SUBJECT: SAFETY RECALL OF CERTAIN 2010 & 2011 MCI D4505 MODEL COACHES WITH A PENNTEX ALTERNATOR

Ref.: **NHTSA # 11V-548**
MCI Service Bulletin 373

Service Bulletin No. 373

MODEL D Series Coaches	TYPE Field Change Program	SECTION/GROUP 7 – Electrical	DATE Nov. 29, 2011
SUBJECT PENNTEX BRUSHLESS ALTERNATOR BRACKET			
CONDITIONS

Figure 2.

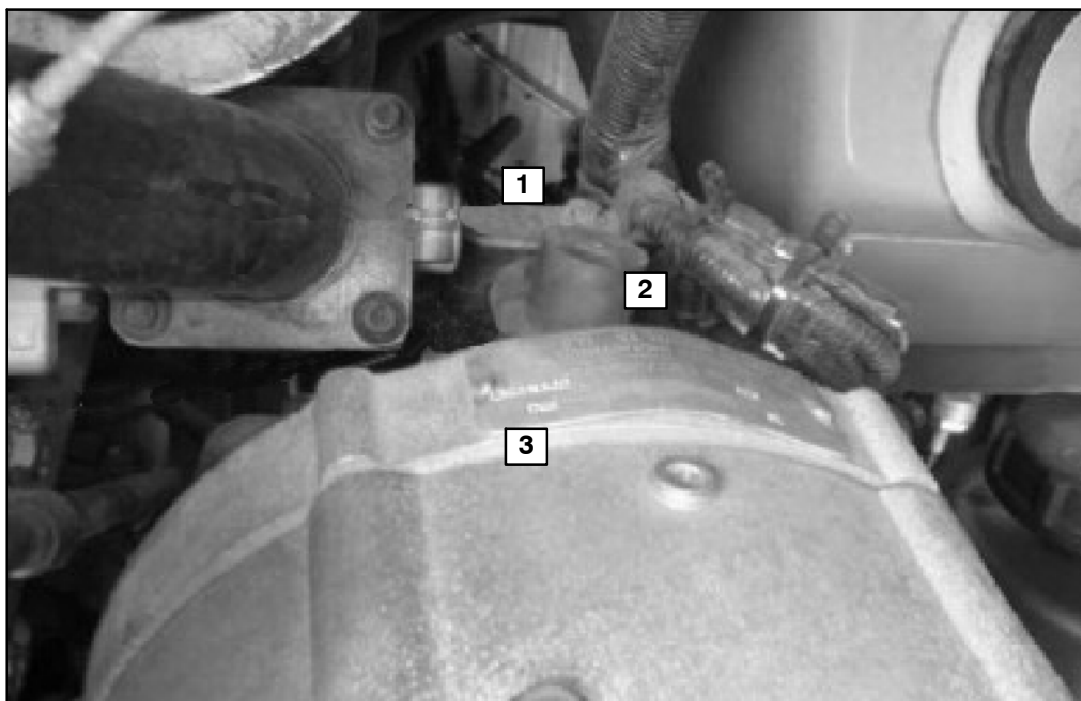
5. Remove the red, rubber protective cap from the B+ (power) stud (refer to Figure 2).

6. Remove and retain the cable clamp to be re-installed at a later step in this procedure (refer to Figure 2).

Figure 4. Reference photos of cleaned B+ stud, stud base and cable terminal.

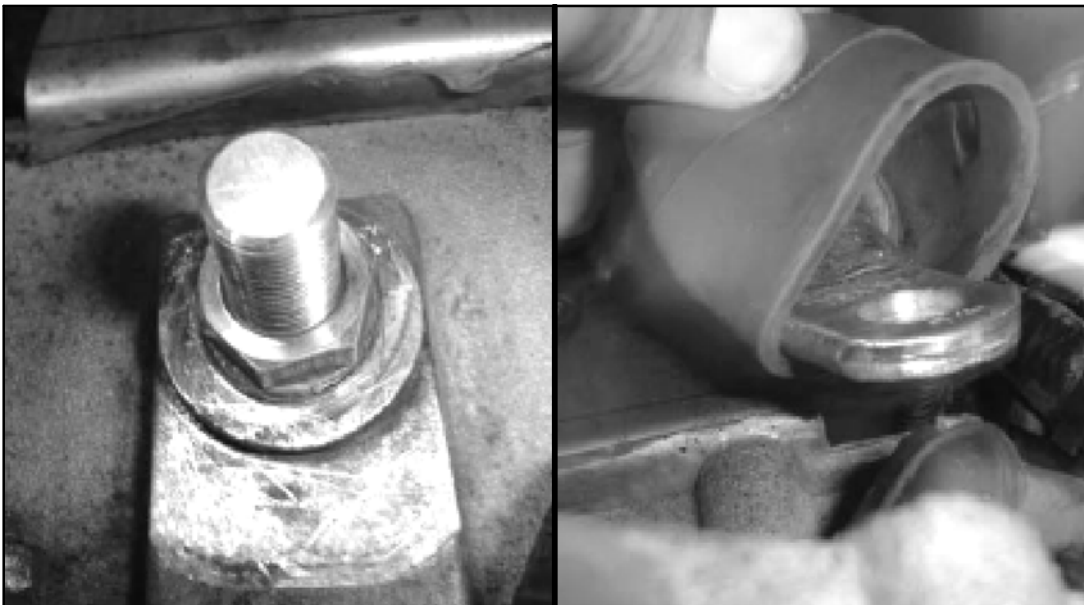
9. Using a clean cloth, wipe away the dirt and grease from the cable terminal, the B+ stud and around the B+ stud base (refer to Figure 4).

Figure 5.

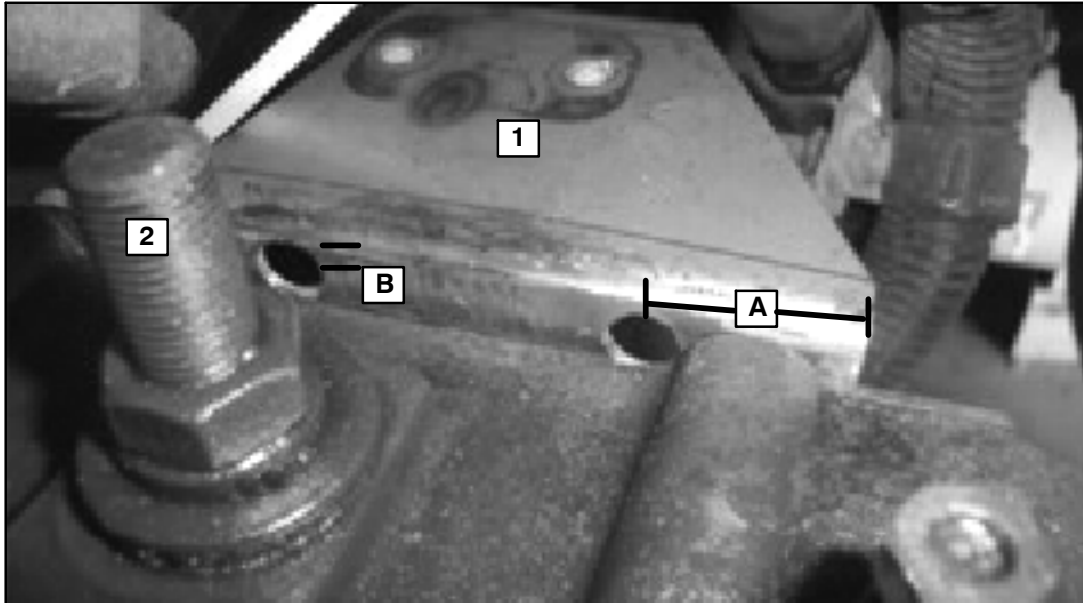
10. Remove the end bracket, shown in Figure 5 and place on a workbench. Using a clean cloth, wipe away the dirt and grease from the end bracket.
11. Using a 3/8 drill bit, drill two (2) holes located 2.0 inches inboard from the outside edges of the bracket and 0.5 inches down from the radius break line (refer to Figure 5). Remove any burrs and/or sharp edges from the drilled holes.

ITEM	DESCRIPTION
1	End bracket
2	B+ stud
A	2.0 inches inboard from both edges of the end bracket
B	Center of drill hole should be 0.50 inches below the radius break line
